Town of Arlington, MA Redevelopment Board

Agenda & Meeting Notice November 7, 2022

3. Public Hearing Docket #3717 80 Broadway

Public Hearing Docket #3722 141 Massachusetts Avenue

Drawn By: MA/ DF

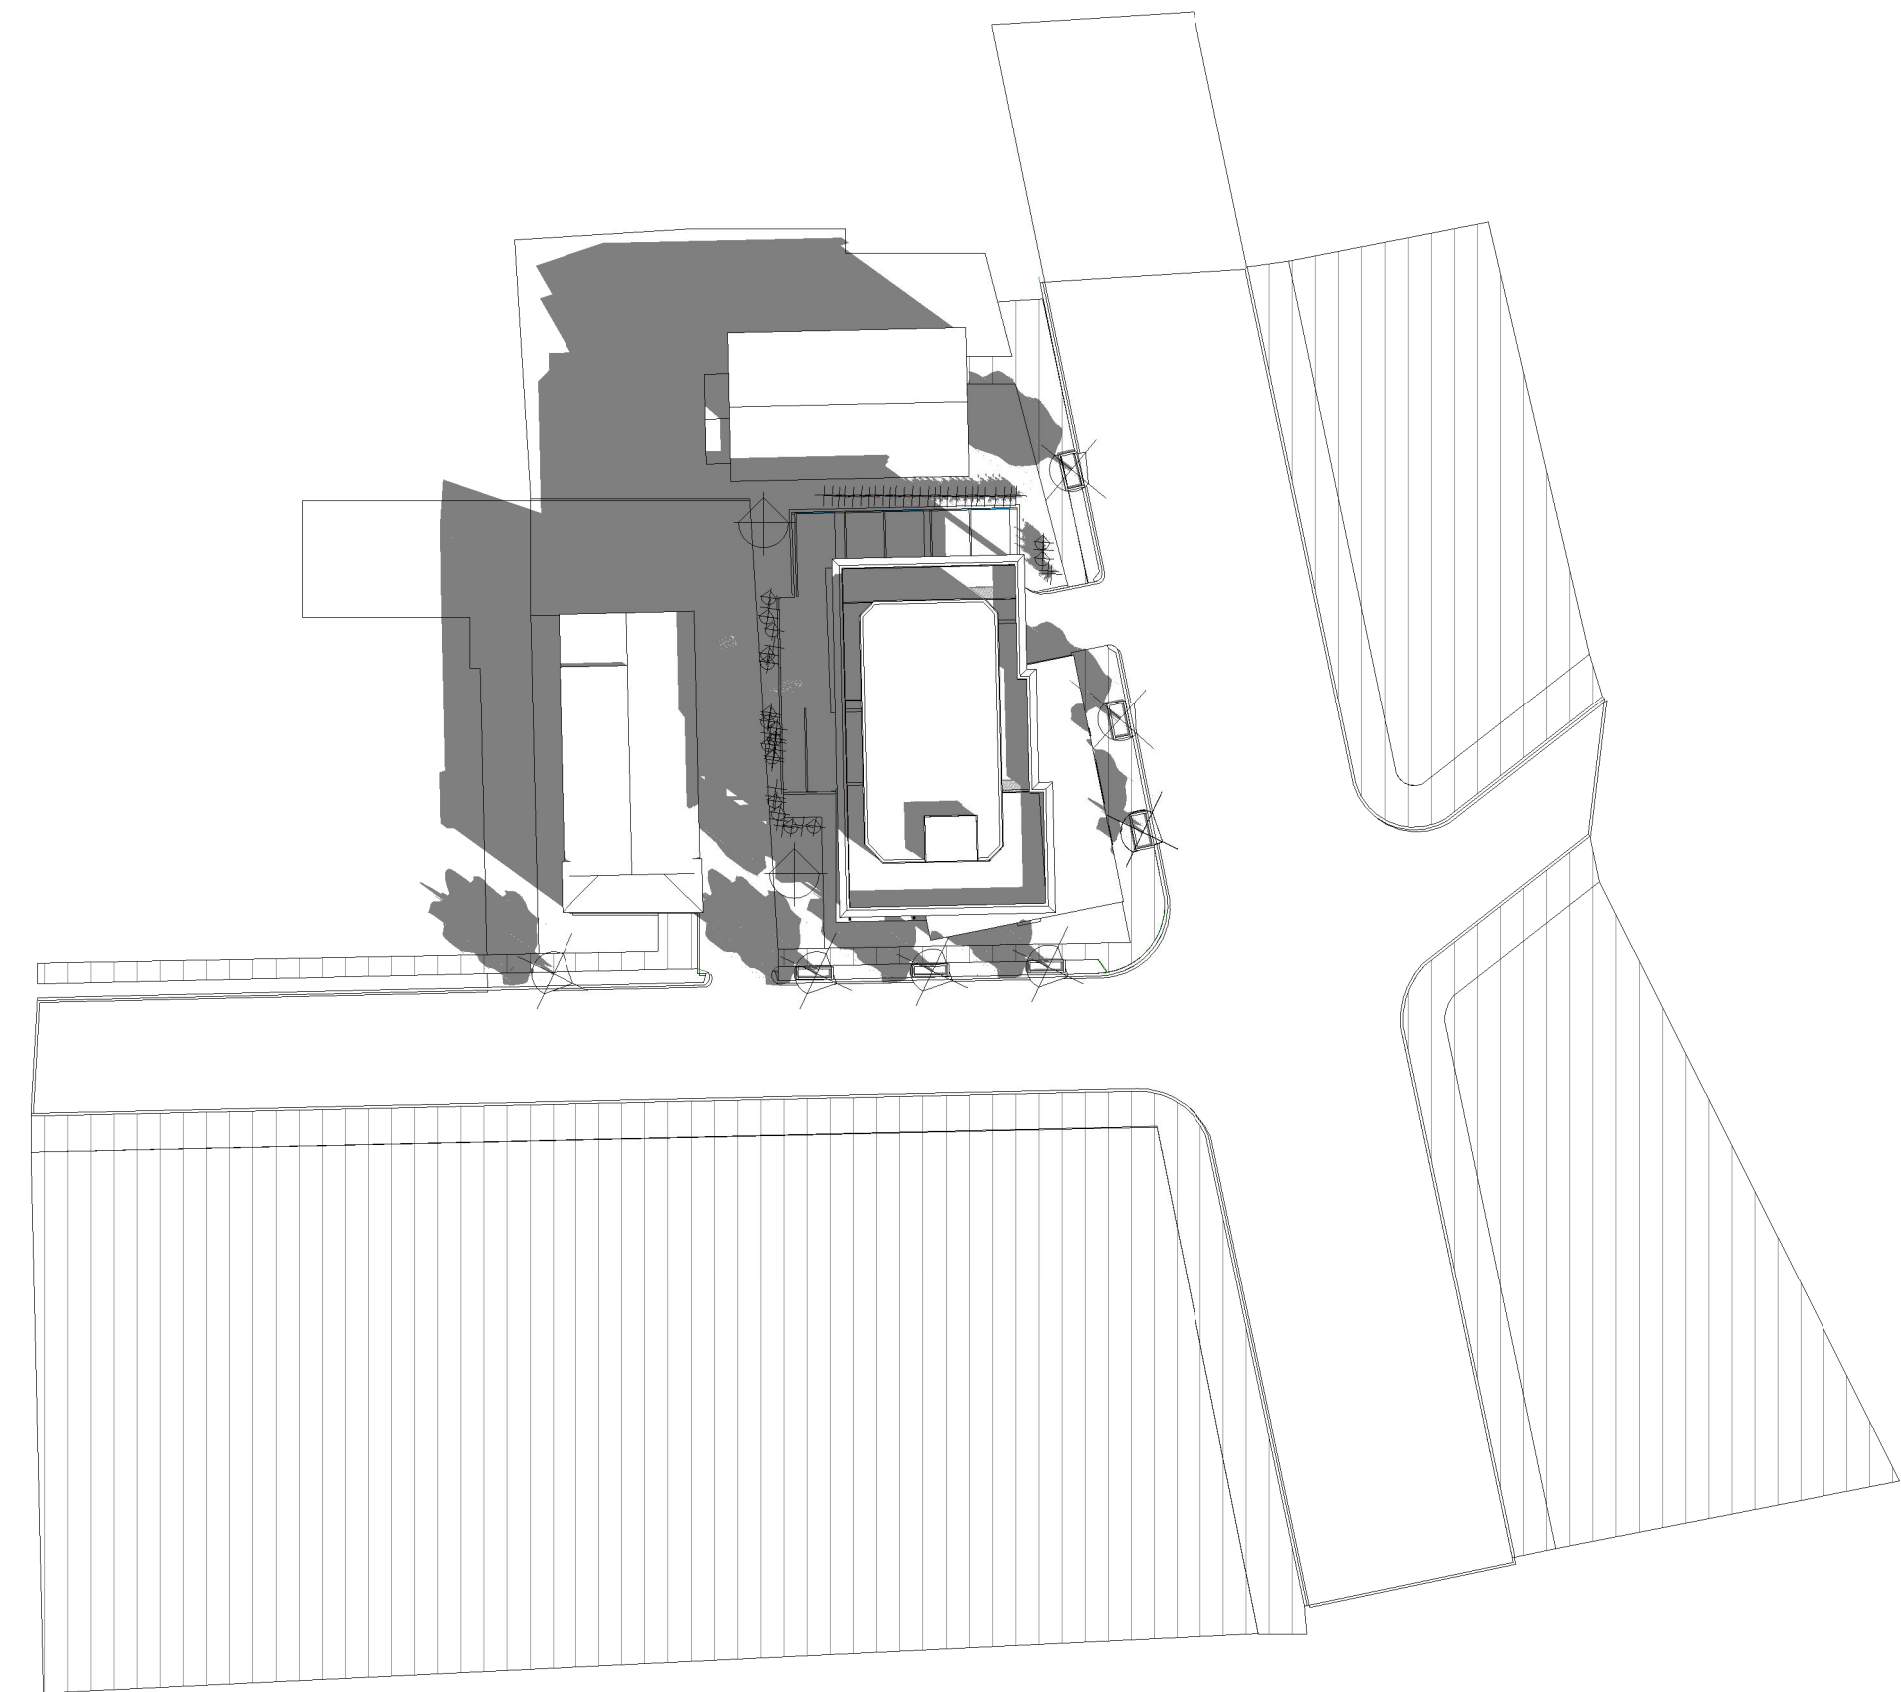
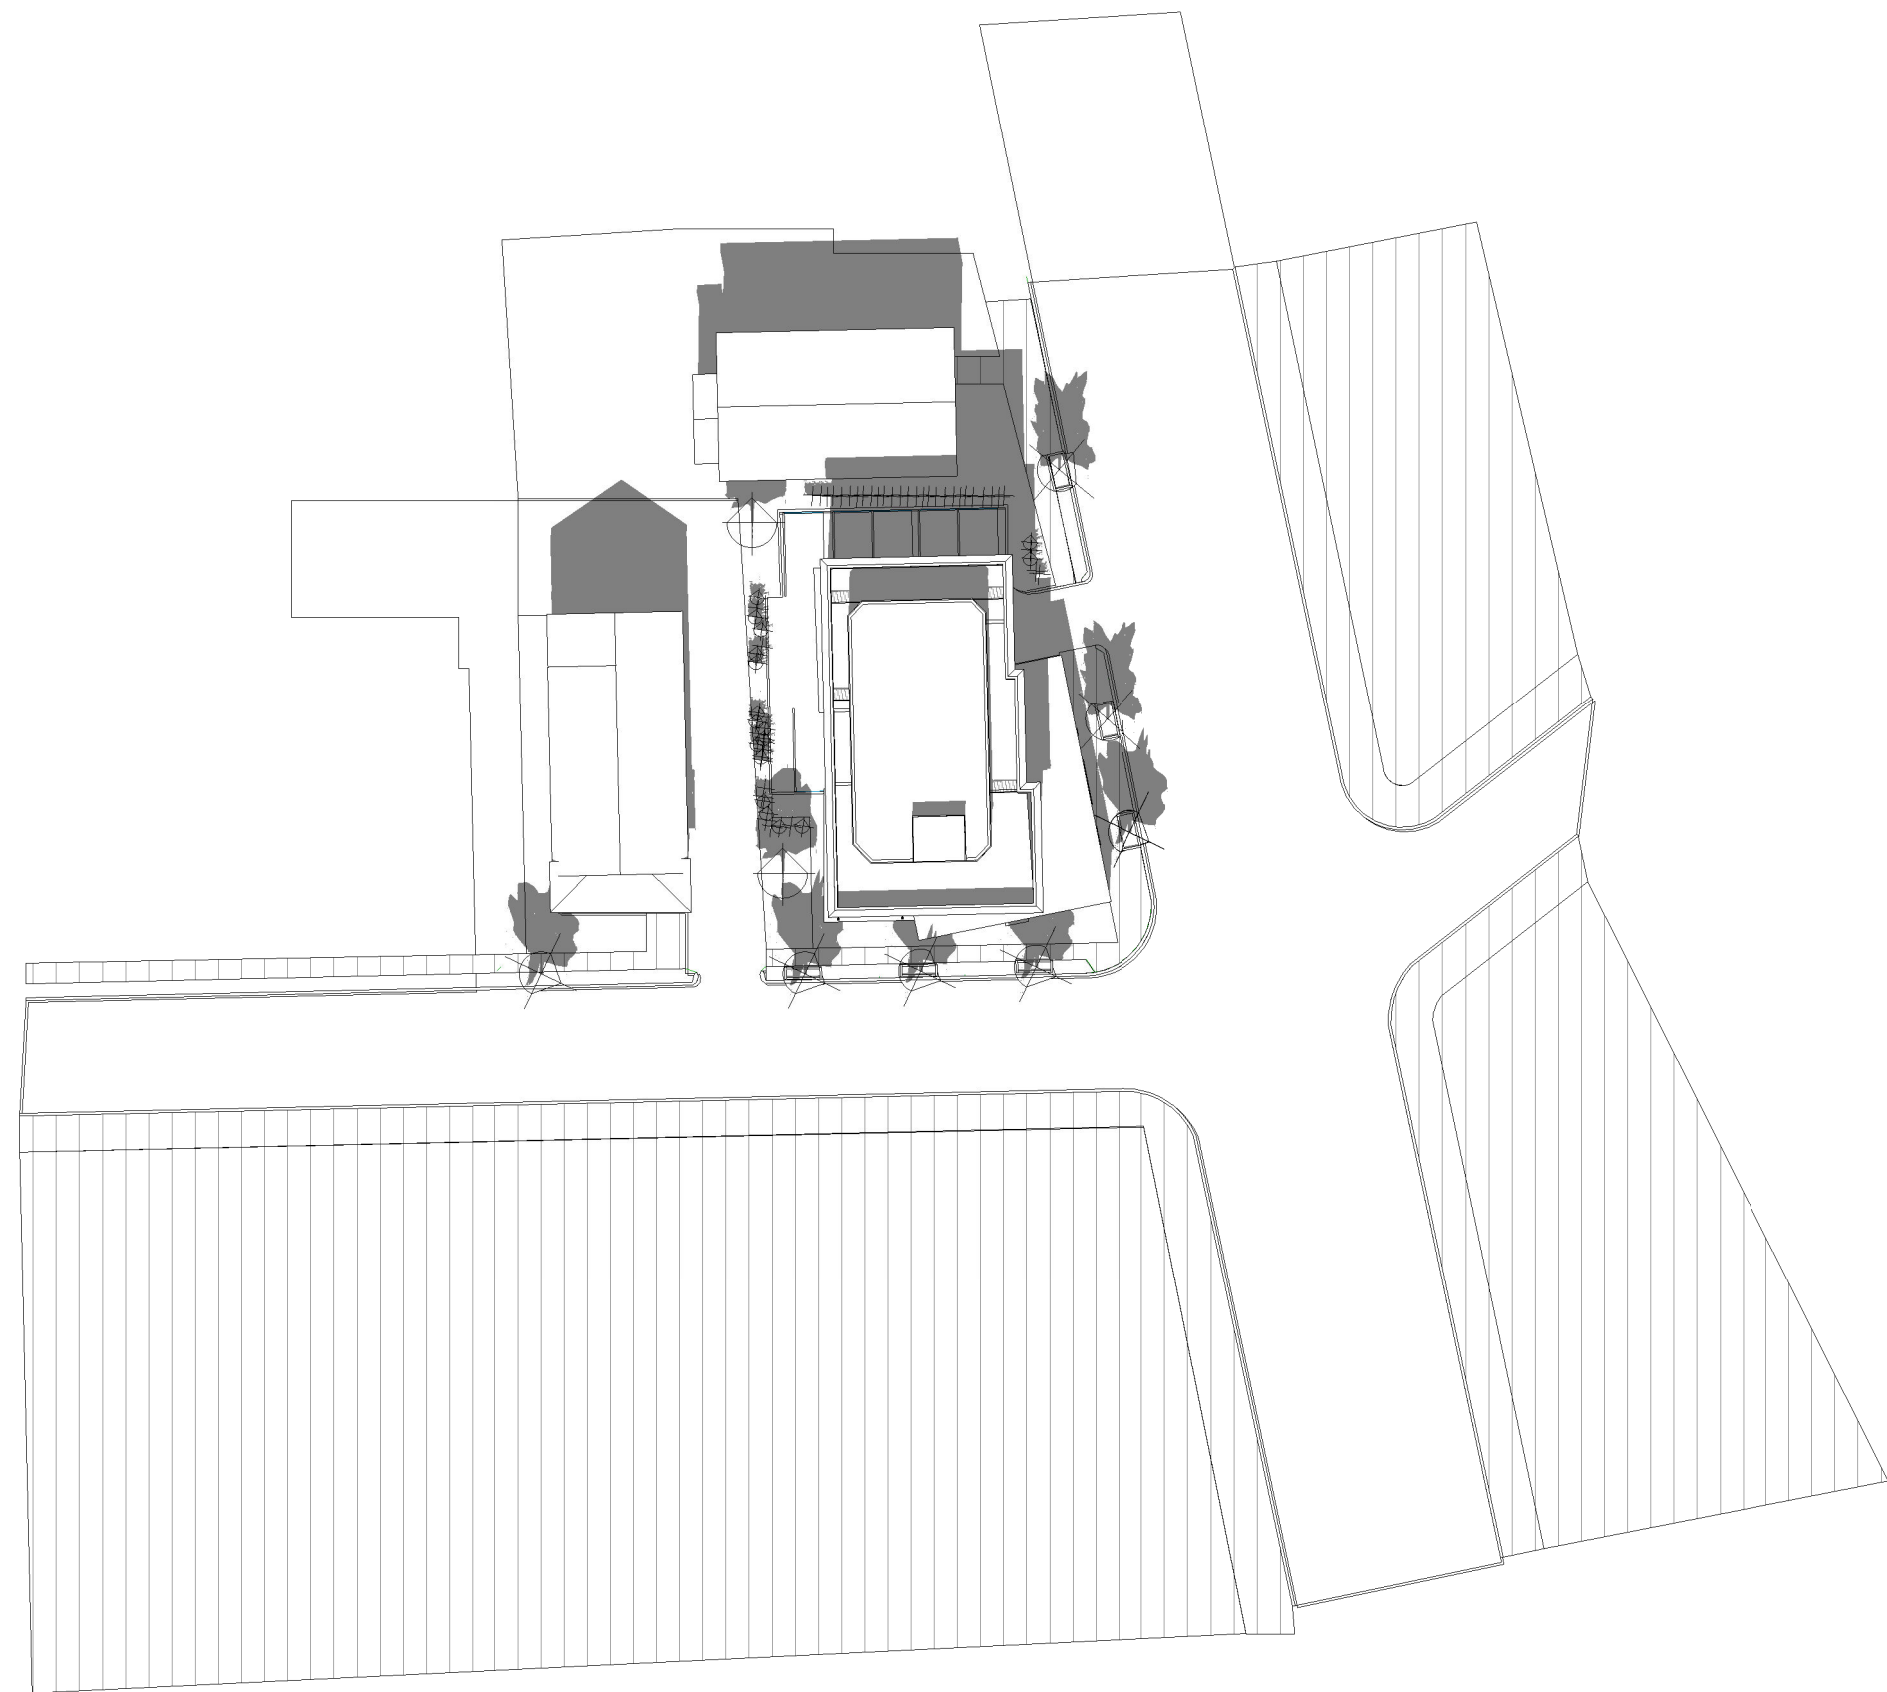
5. Could the applicant provide the Board with corrected and more detailed solar impact drawings A2.10 - A2.13? These drawings incorrectly show Broadway as running North to South, more than 60° off from reality. These drawings omit any detail of the affected properties, notably the array of solar panels on the roof of 88 Broadway.
